# Access Compliance Report

## Public Rights-of-Way

| Intersection ID: 14648   |  | Main Street: EAST_BV    |  | Cross Street: LENNOX_AV                 |                       | Location: NE           |            |                             |      |
| ADA ID: 0524964FE81A   |  | Ramp Type: Directional1 |  | Initial Pass/Fail: Fail                 |                       | Overall Compliance: No |            | Severity Score: 12.5        |      |

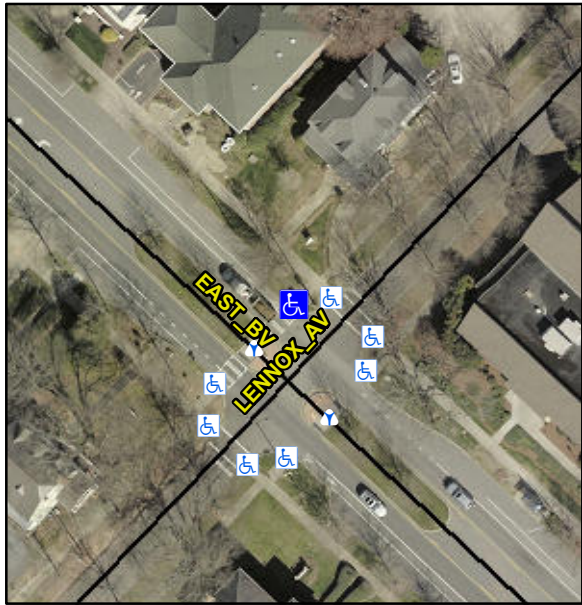
|  |  |                         |  | No                                      | Ramp Slope (%)        | 8.7                    | N/A        | Grade Break XSlope (%)      | 0.0  |

| <div></div> <div>Street 1 NameEAST BV</div> <div>Stop Condition-Street 1None</div> <div>Street 2 NameN/A</div> <div>Stop Condition-Street 2N/A</div> <div>Possible Solutions:<br/><b>Remove &amp; Replace Entire Ramp.</b></div> <div>Surveyor Notes:<br/><b>N/A</b></div> <div>PROW/ADA:<br/><b>R304.2.2</b></div> <div>Total Cost:\$ 1600.00</div> |  |                         |  | Compliance                              | Description           | Data                   | Compliance | Description                 | Data |
